SERVICE BULLETIN 98

SUBJECT: SLOTTED FLAP HINGE POINT CORRECTIONS

APPLICATION: All Slotted Flap Kits shipped before 1/24/91

FIGURE (1)

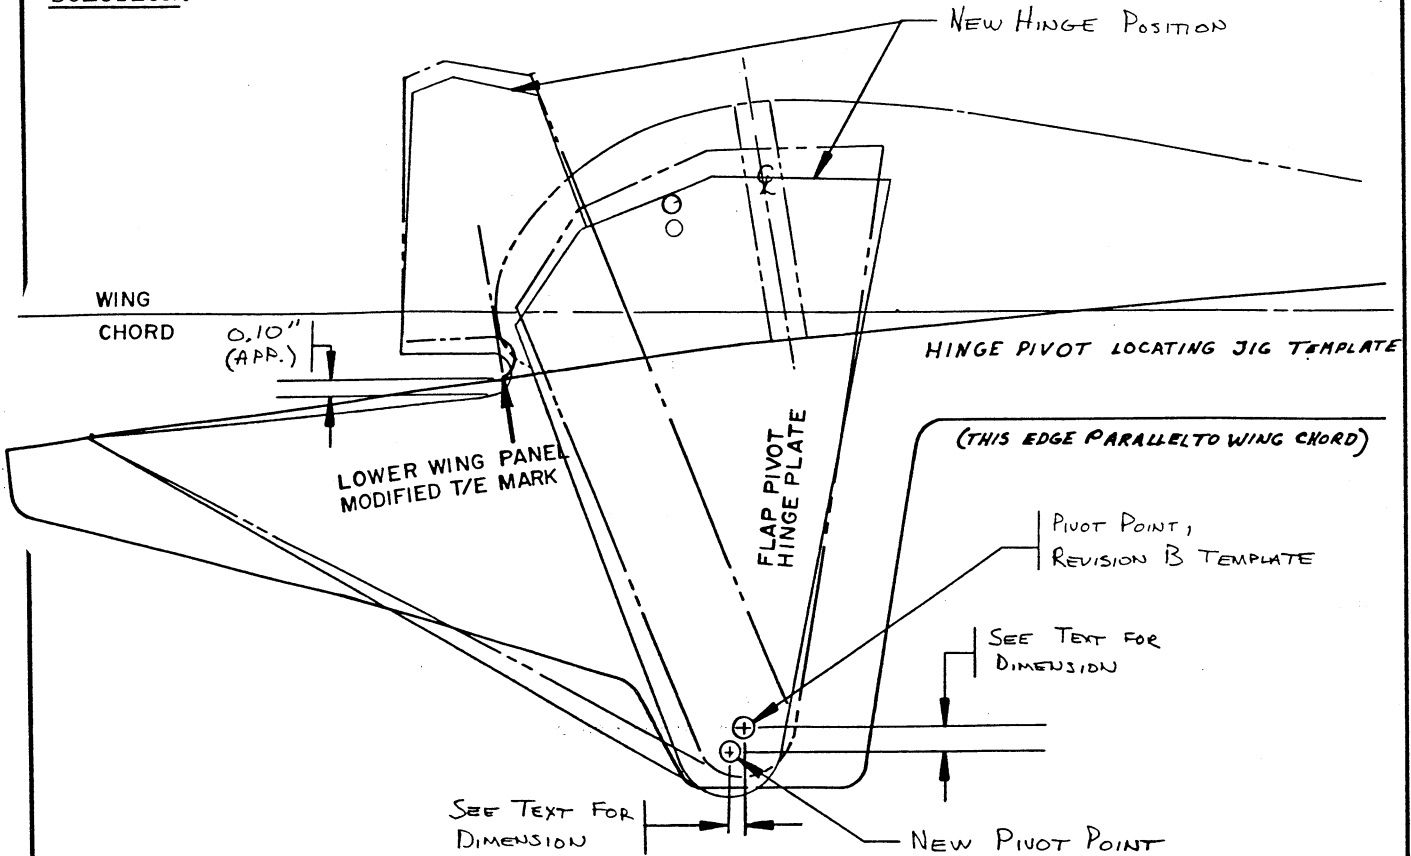
Some builders have experienced problems when using the Revision B Hinge Locating Jig Templates. In some cases, the templates position the flap hinge pivot plates too high so they extend too close to the upper surface of the flaps. This, in turn, causes the rod-end bearing on the actuator rod to protrude above the upper surface of the flap. One cannot simply drill a new hole and trim off the top of the pivot plate, because this changes the lever arm for the actuator.

If you experience a problem with the flap actuator rod-ends protruding above the upper surface of the flap, the only thing you can do is to lower the flap hinge pivot point to get everything back inside the flap without changing the lever arm for the actuator. Try locating new hinge pivot points on the Revision B Hinge Locating Jig Templates, as shown in FIGURE (1) and as described in the following table:

- Inboard Hinge: locate the new hinge pivot point .16" below and .13" forward of the existing pivot point shown on the Revision B Hinge Locating Jig Template.
- Outboard Hinge: locate the new hinge pivot point .16" below and .11" forward of the existing pivot point shown on the Revision B Hinge Locating Jig Template.

- Both Hinges: locate new hinge pivot points .22" below and .08" forward of the existing Revision B Hinge Locating Jig Templates.

To achieve the new hinge point position, rest the leading edge of the wing attach plate against the lower surface of the wing and rotate the aft end down. This will require trimming some material off the notch cut in the attach plate to clear the lower spar cap, and will leave approximately a 0.1" gap between the lower wing skin and the wing attach plate at the modified wing trailing edge. If you trim the wing attach plates, be sure to remove all sharp edges and scratches in the relieved areas. Accomplish this at both the inboard and outboard hinge plates. This modification should be enough to get the flap hinge pivot plate back inside the flap.
